Subject: Preliminary Questions in Chapter 2 of the STP COLA
Sent Date: 3/11/2008 11:28:35 AM
Received Date: 3/11/2008 11:28:35 AM
From: Raj Anand

The following table represents a draft list of discussion items that will be discussed during the safety site audit for the STP Units 3 & 4 COLA FSAR Chapter 2. Additional items or changes may be added to the existing list, based on discussion and review.

Preliminary Information Needs for the STP Safety Site Audit

Figure 1
STP Stability Class Frequency Distributions

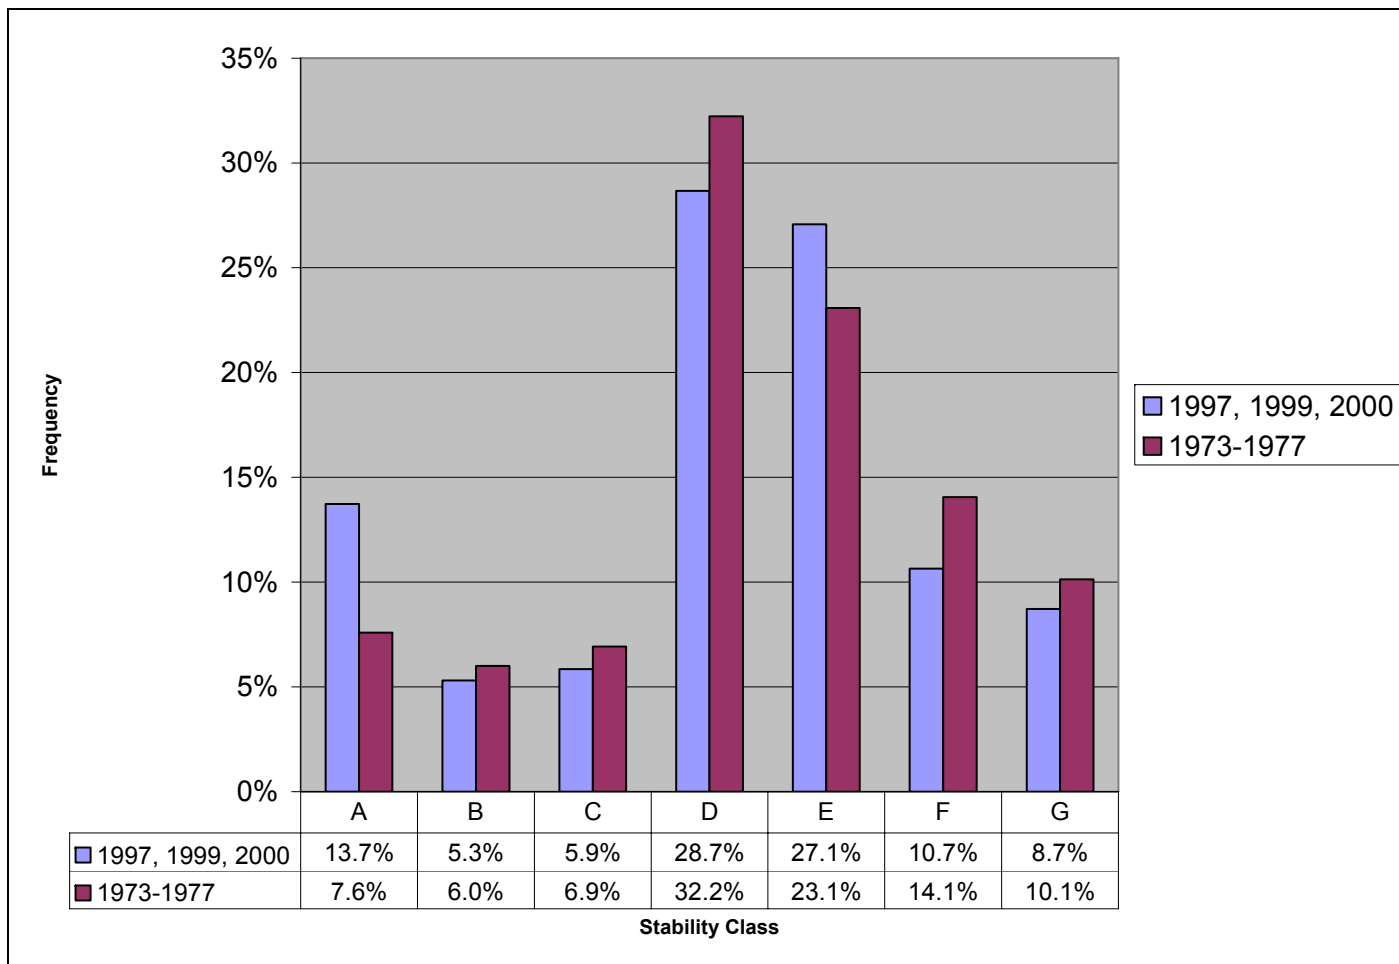
23.	2.3S.3.4.1.2	Meteorology	Please explain the 6% increase of onsite A stability class frequency from the original data set (1973-1977) to the current (1997, 1999, and 2000) data set as shown in FSAR Table 2.3S-20 (see Figure 1).	Brad Harvey
